RUNWAY PLANS REPORT FROM GACC

Gatwick Unwrapped

A critical examination of the plans
for a second runway at Gatwick
January 2014

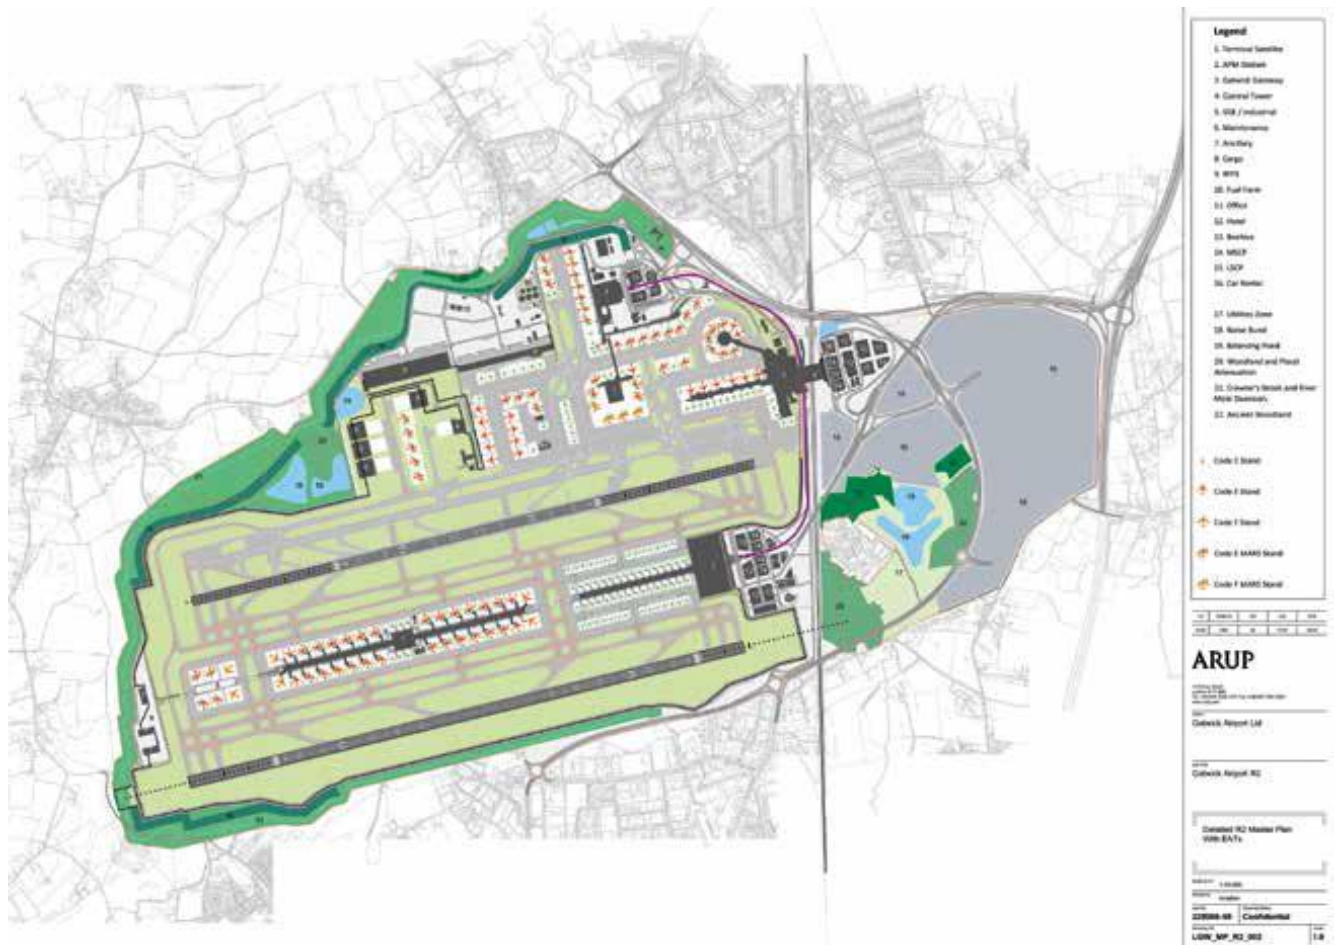
16. Proximity to Crawley. The airport plan published by the Commission (below) shows that the new runway would lie only about 400 yards north of the residential areas of Crawley. The new airport boundary would be within 100 yards of the most northern houses.⁶ It would only be 150 yards from an important Hindu temple.

17. A new earth bund is shown (dark green) on the south west corner of the enlarged airport, and this is welcome. It would, however, only be relevant to the 25% of flights taking off towards the east, when it would reduce engine noise at the start of the run. No visual or acoustic protection is shown to protect residents in the eastern part of Langley Green. **GACC will tell the Commission that the earth bund must be continued all the way to the old A23.**

27. Ifield, with its historic church (grade1) and attractive Conservation Area would be badly affected by ground noise. **We will tell the Commission that it would be essential that the earth bund shown on the plans is at least 15m high.**

28. Charlwood, a historic village with over 80 listed buildings, would be particularly affected by the proposal to build four new hangars on the north west side of the airport.¹⁹ We are glad to see that the map published by the Commission now includes a new bund around the north west of the airport. **We will tell the Commission that to provide the minimum visual and acoustic protection this would need to be over 15m in height.**

there appears some confusion on this point. The map published by the Commission does not show any such taxiways.²⁰ On the other hand the Commission's report on Operational Efficiency assumes that they will be provided, and that failure to provide them would 'compromise capacity, efficiency, resilience and safety'.²¹

Annex 3: Gatwick Airport Second Runway – Indicative Arrival and Departure Paths

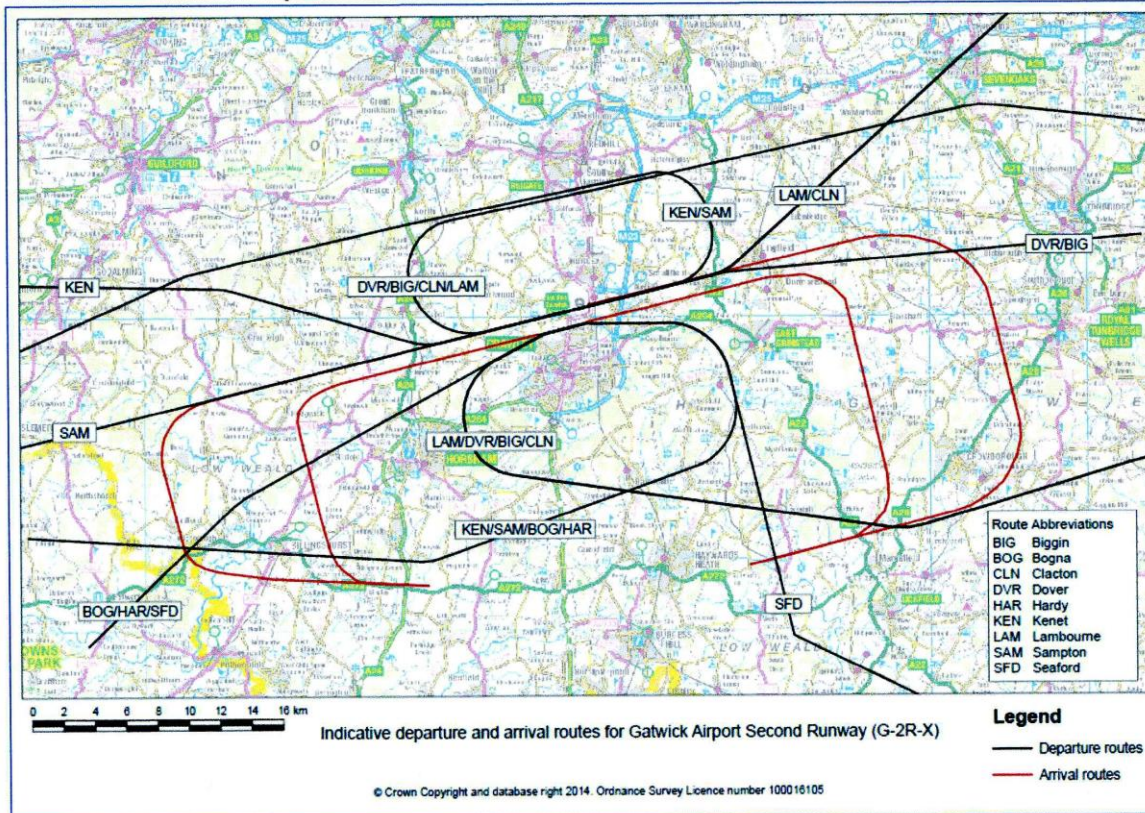
34. New flight paths. The Commission has published a map (shown below) of the new flight paths with a new runway.²⁶ They emphasise that this is only illustrative and does not represent where the routes might actually be. One of the basic flaws of airport planning, in Britain and other countries, is that the actual flight paths are only decided after permission is given to expand an airport, causing many people to feel misled and aggrieved.

35. Nevertheless certain conclusions can be drawn. Aircraft departing from the existing runway are shown using the present flight paths, except that no routes to the south are shown. Thus the number of aircraft using the present routes would approximately double.

36. All aircraft departing to the west from the new runway are shown as using two new flight paths, one over Warnham and North Horsham (on the track of the immensely unpopular ADNID trial); and one turning sharp left to fly over the eastern side of Horsham. Since these two flight paths would need to take all aircraft taking off to the west from the new runway, Horsham could at busy times of day experience up to one plane a minute over either the north or the east of the town.

37. All aircraft taking off to the east are shown as taking a route over Cophthorne and Crawley Down, and close to East Grinstead which, at busy take-off times, would also suffer one plane a minute.

38. Arriving aircraft on both runways are shown as taking two concentrated flight paths to the east or two to the west, from a 'merge point' (or perhaps two 'merge-points') in the vicinity of Haywards Heath.
